35/13-01A 9 West Melrose Street
(Chevy Chase Village HD)

35/13-01A 9 West Melrose Street
(Chevy Chase Village HD) REVISION

Revision to approved plan: remove - rather than support with beam - east
side chimney

PROPOSAL: Remove all of the original chimney on the east side of the house; proceed with previously approved side addition. Add dormer on east hip of main roof.

EAST

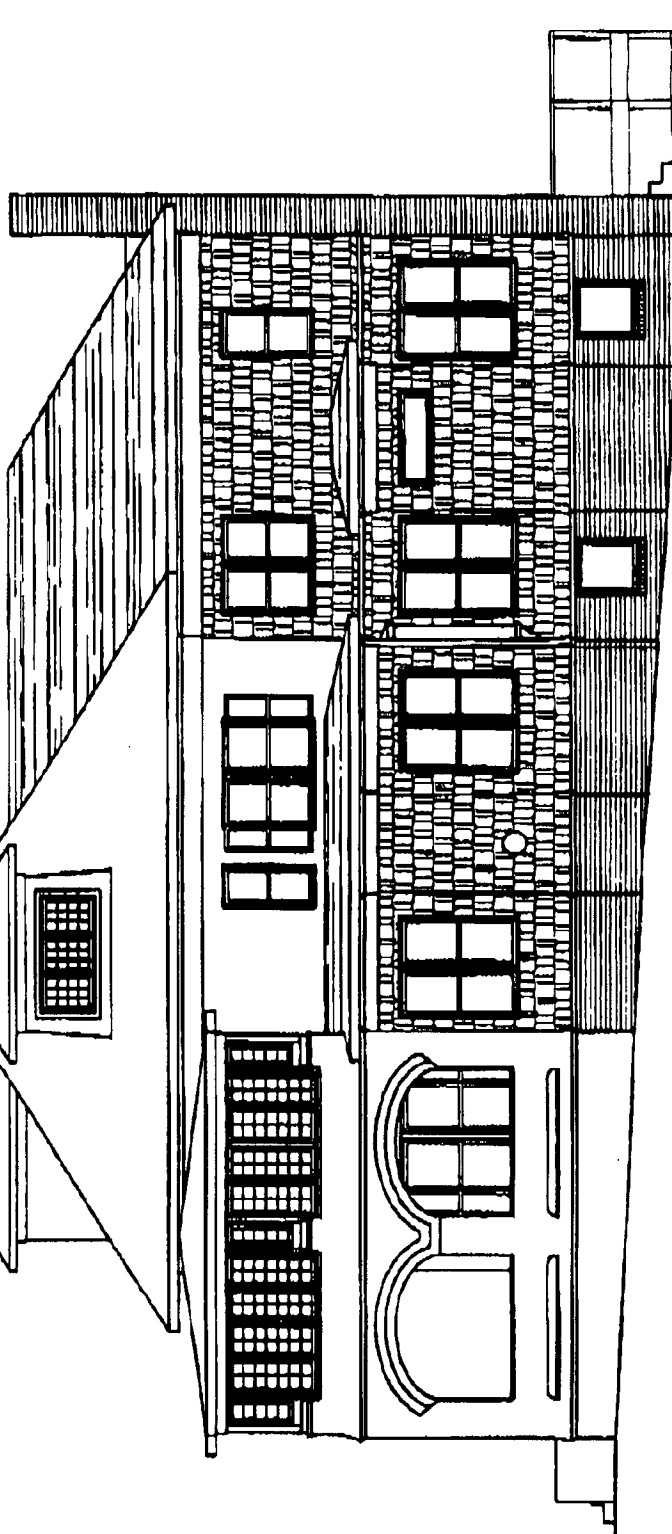
The applicant proposes to remove the original brick chimney on the east side of the house in its entirety. The applicant then proposes to construct a new dormer in the east hip of the roof, which would replicate the existing dormers on the west and south roof hips.

Staff recommends against the proposal because the new revision does not preserve the original design intent of the structure, would remove original material, would remove an original feature, and would be misleading in terms of the actual history of the site. In any historic district, secondary resources are still significant structures and integral to the district's story.

REAR (7)

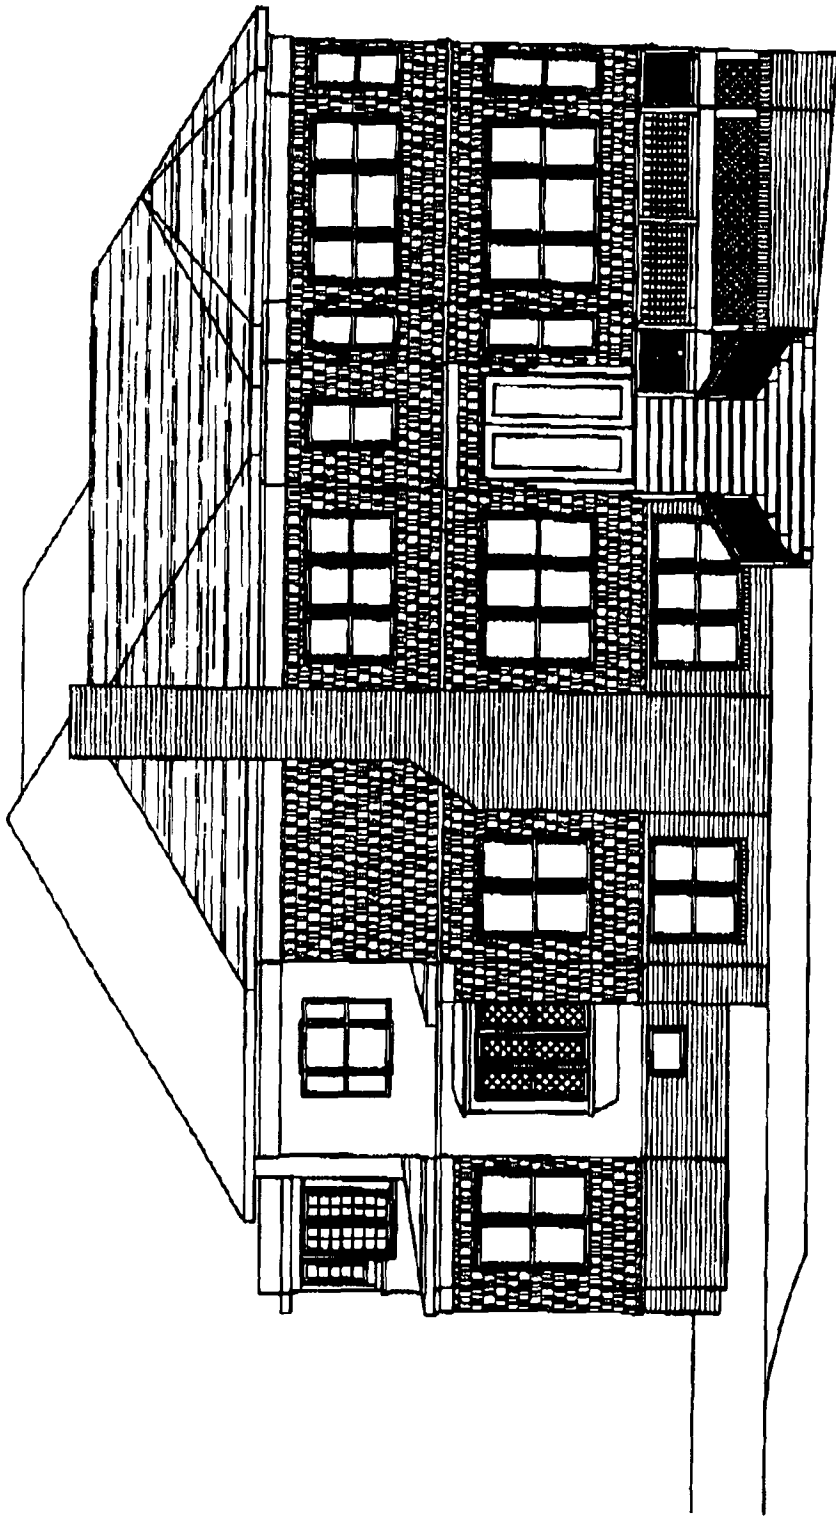
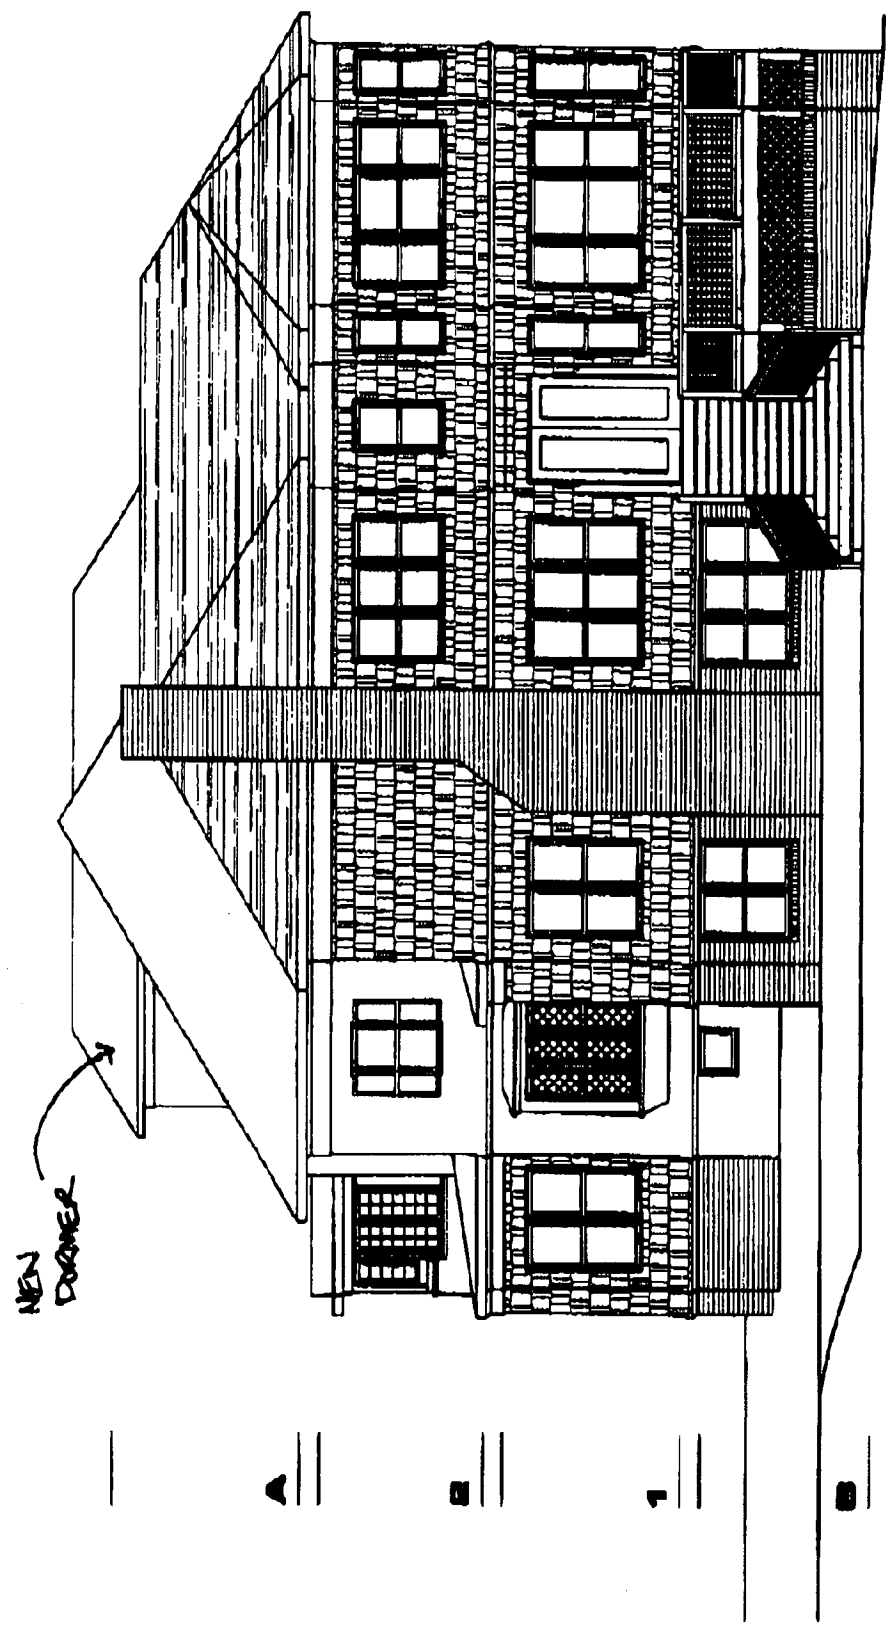
HERE ARE ELEVATIONS YOU CAN SEND
TO ROBIN. 1 → 4 AS APPROVED
2 → 8 PROPOSED REMOVAL OF CHIMNEY
9 → 12 WITH NEW CORNER.

Alternative Plan (staff proposal)

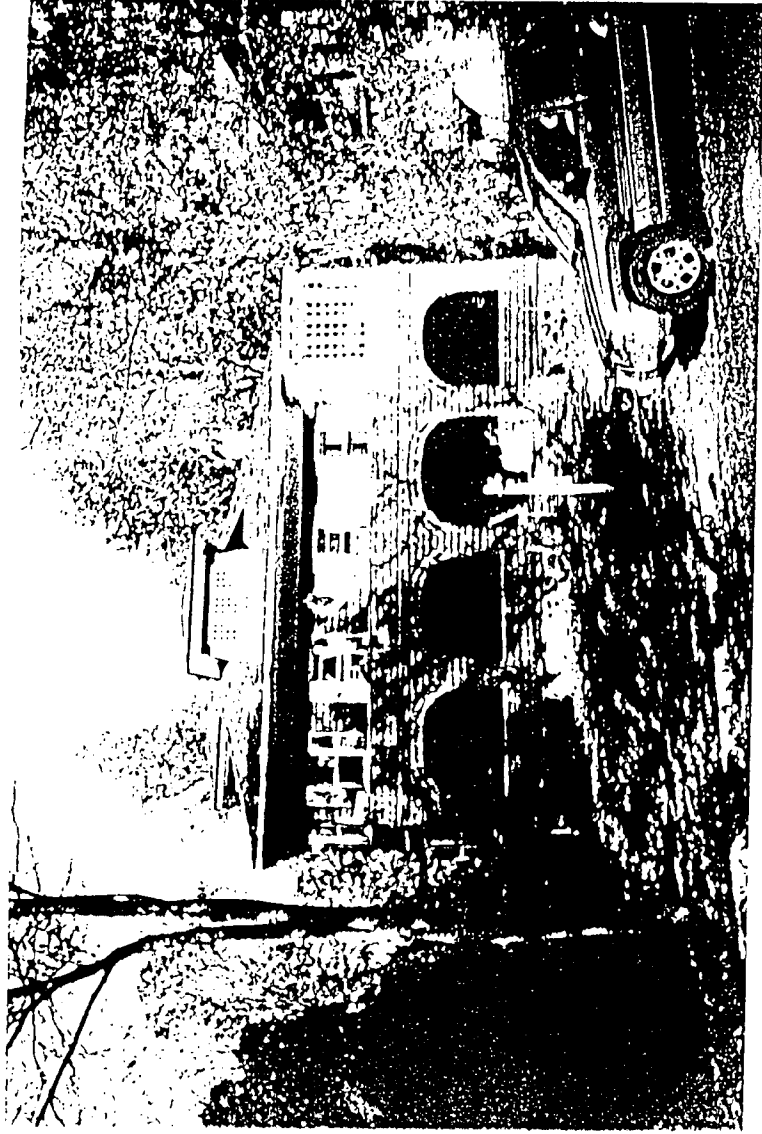
Modifies plan but
retains "Four Square"
elements.

Retains original stair hall,
oriel window in situ
